Burlington Development Review Board

Development Review Board

Wednesday, March 25, 2026, 5:00 PM

To: Development Review Board
From: Mary O'Neil, AICP, Principal Planner
Date: March 25, 2026
RE: ZP-26-54; 49 Henderson Terrace

Project Name!

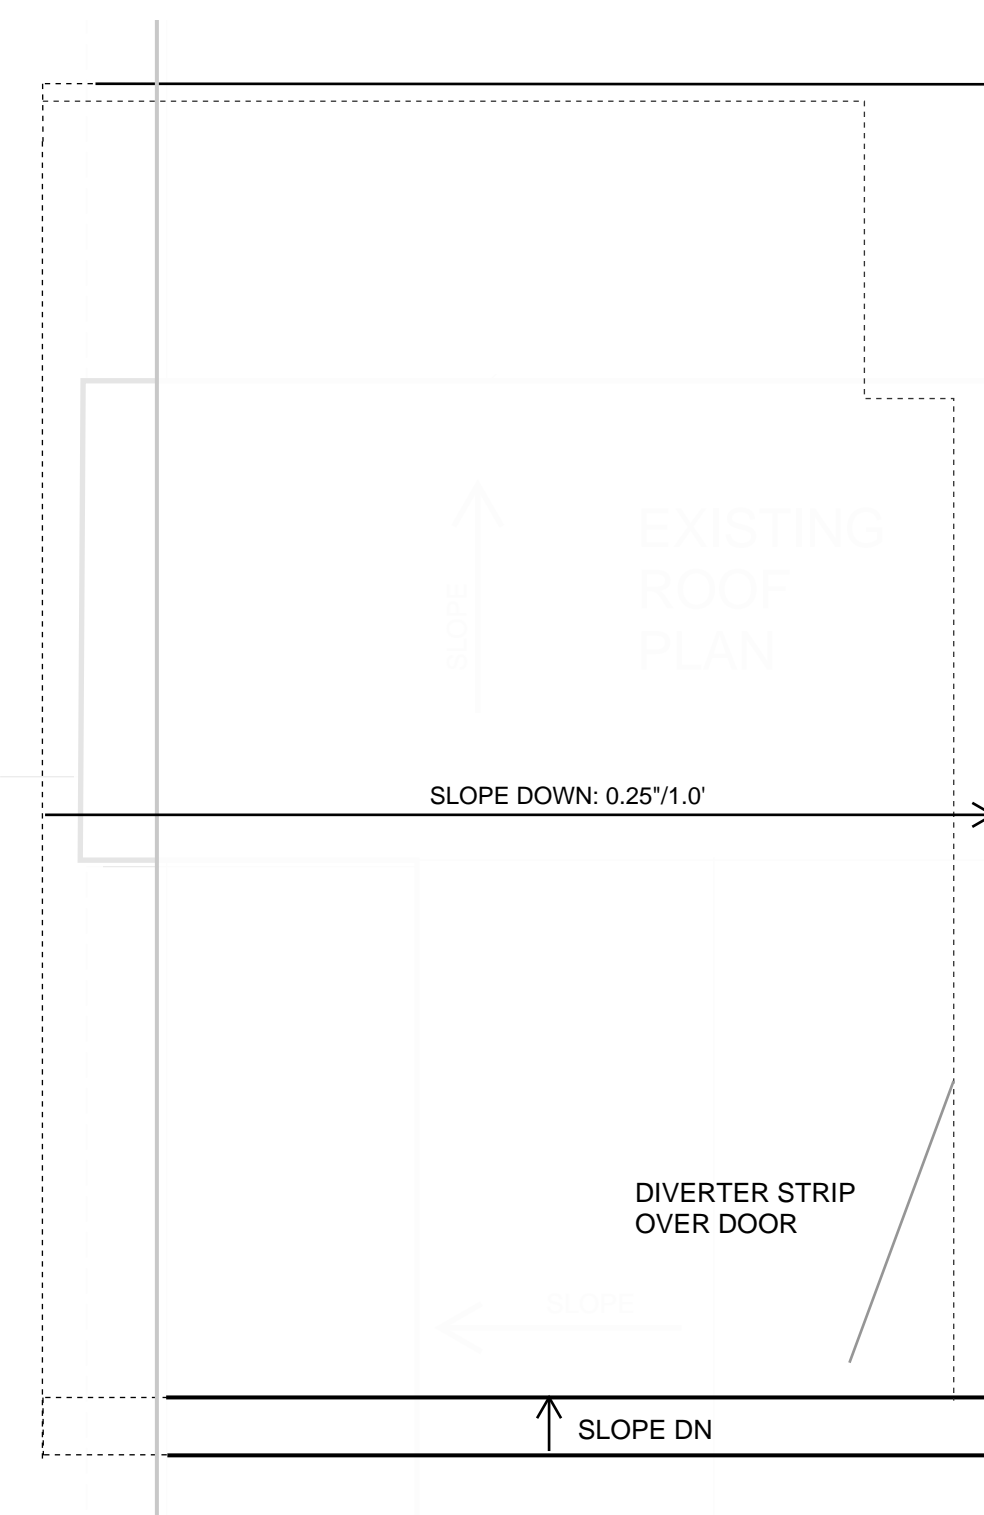
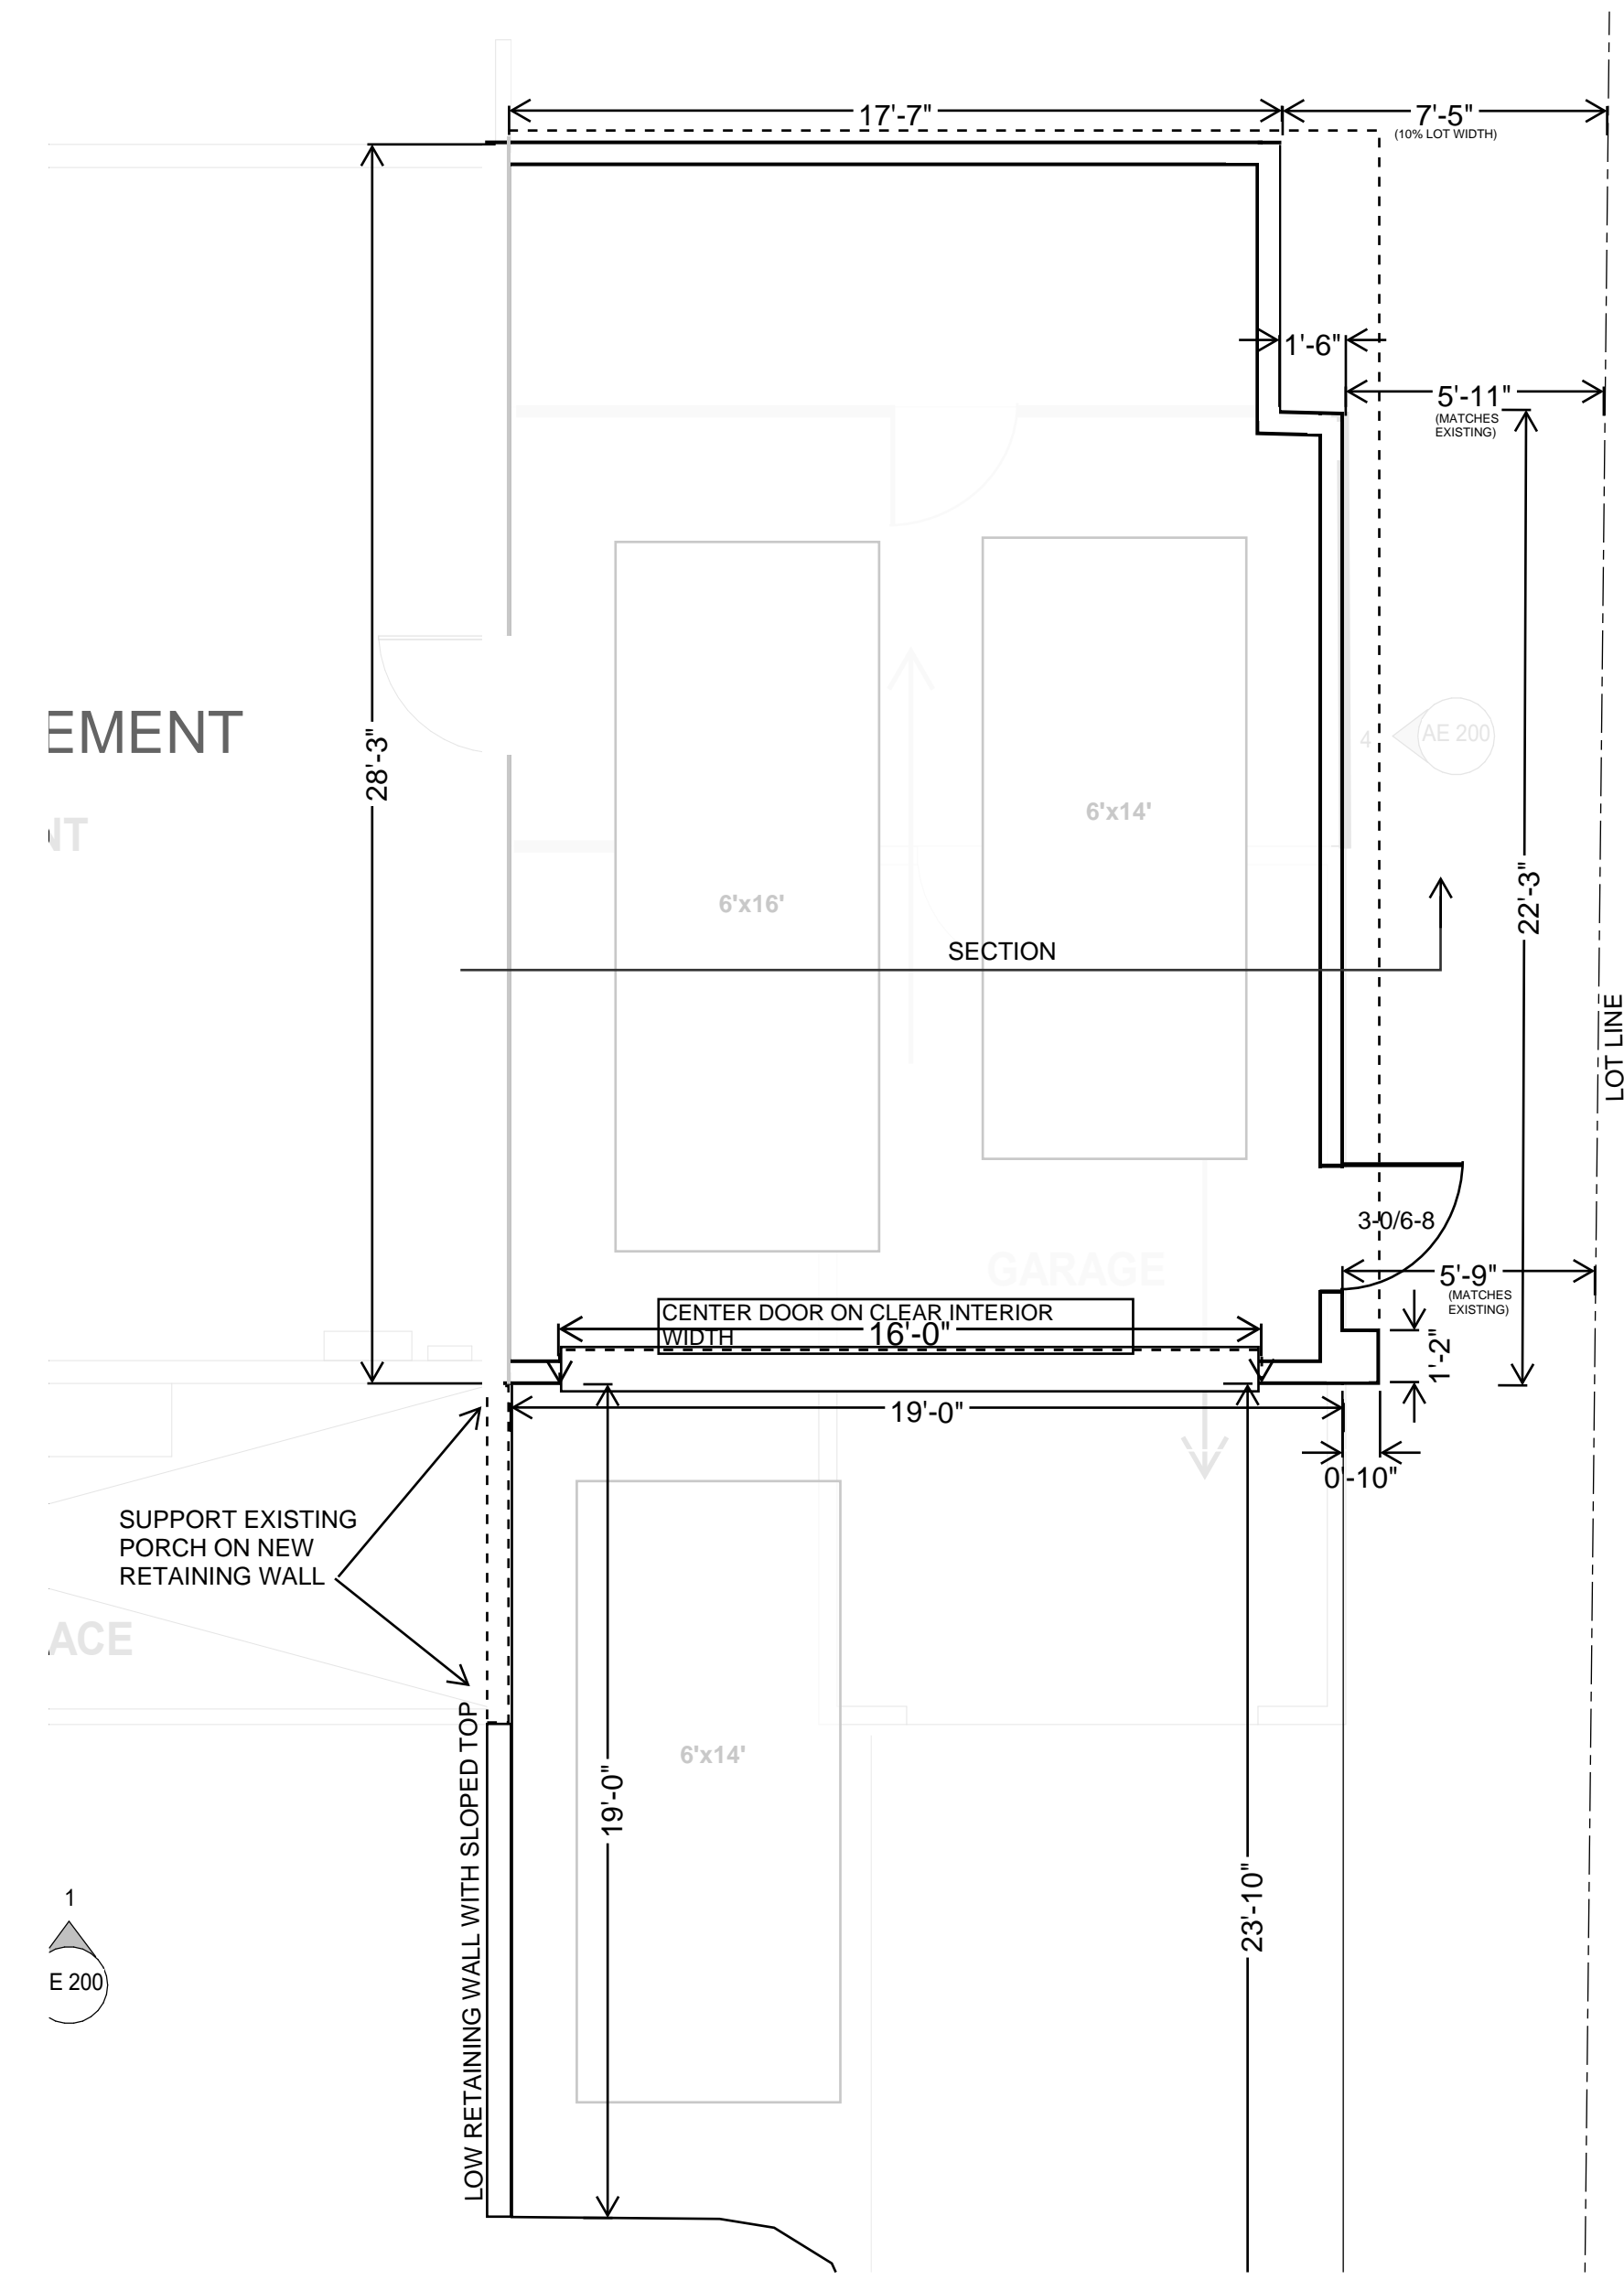
Part of the garage foundation includes a structural retaining wall to support the existing front porch. Reference is made to plans S100. **Affirmative finding.**
